Wisconsin Department of Transportation

Proposal #03: 5350-02-65, WISC 2026130
C Janesville, Center Avenue
UP RR Structure B-53-135
USH 51
Rock County

5350-02-75, WISC 2026131
C Janesville, Center Avenue
W State St to WSOR Bridge B-53-154
USH 51
Rock County

This is Addendum No. 01, which provides for the following:

Addendum No. 01
 ID 5350-02-75
 Revised Sheet 17
 May 4, 2026

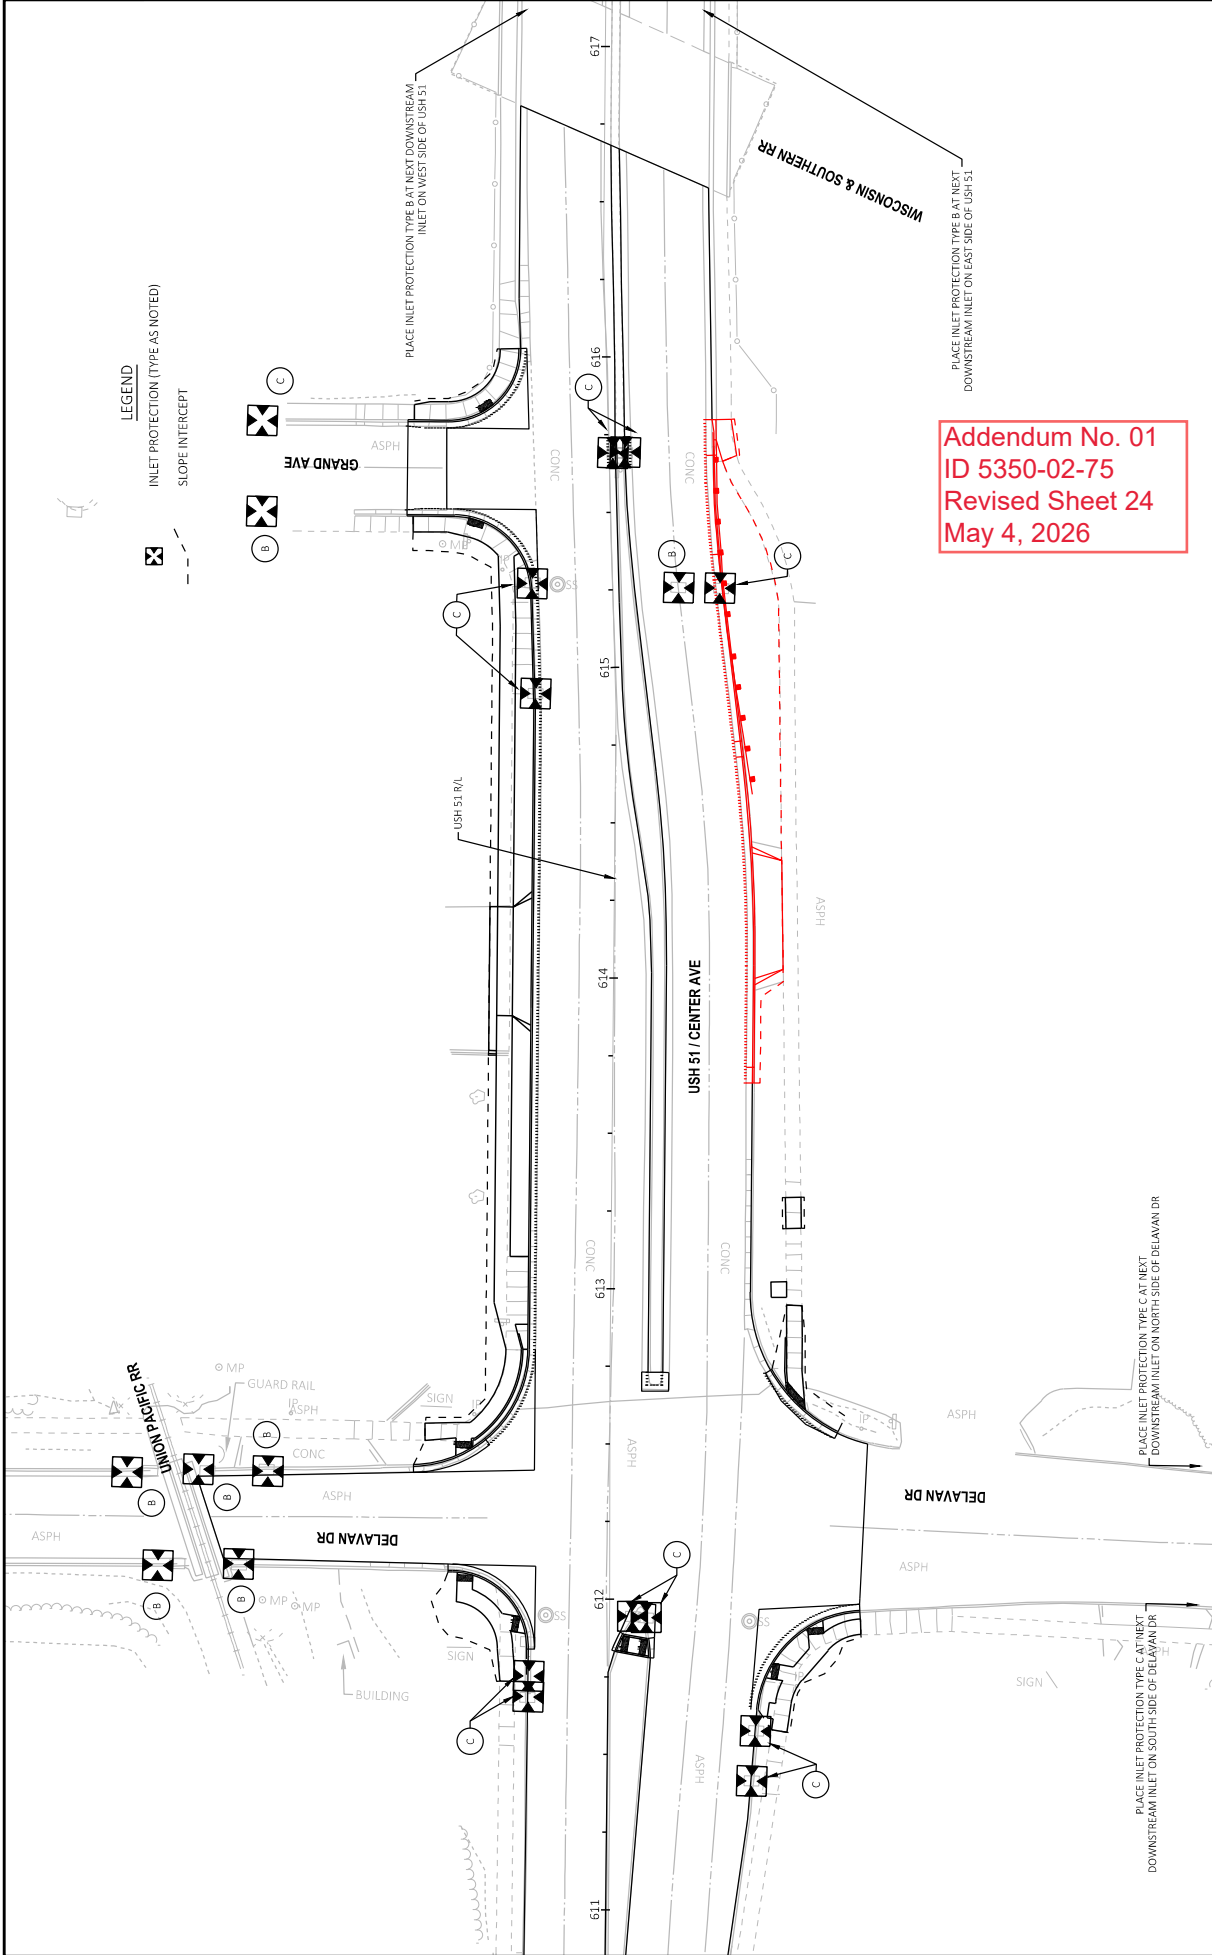
Revised Plan Sheets	
Plan Sheet	Plan Sheet Title (brief description of changes to sheet)
3	Project Overview (added guardrail)
7	Typical Sections (added dropdown for guardrail)
14	Removal Plan (additional removals related to guardrail)
16, 17	Plan Details (added guardrail and additional survey points, revised survey point table)
24	Erosion Control (added guardrail to background)
25	Storm Sewer (added guardrail to background)
27	Signing & Pavement Marking (added guardrail to background)
44	Traffic Control – Stage 2 (Temporary Pedestrian Access Stage 2D) (added guardrail to background and revised work zone hatching)
52	Temporary Pedestrian Access Overview (Stage 2D) (added guardrail to background and revised work zone hatching)
59 – 61, 64	Miscellaneous Quantities (revised various quantities associated with new guardrail)
168	Cross Sections (revised and added cross sections to depict new guardrail)
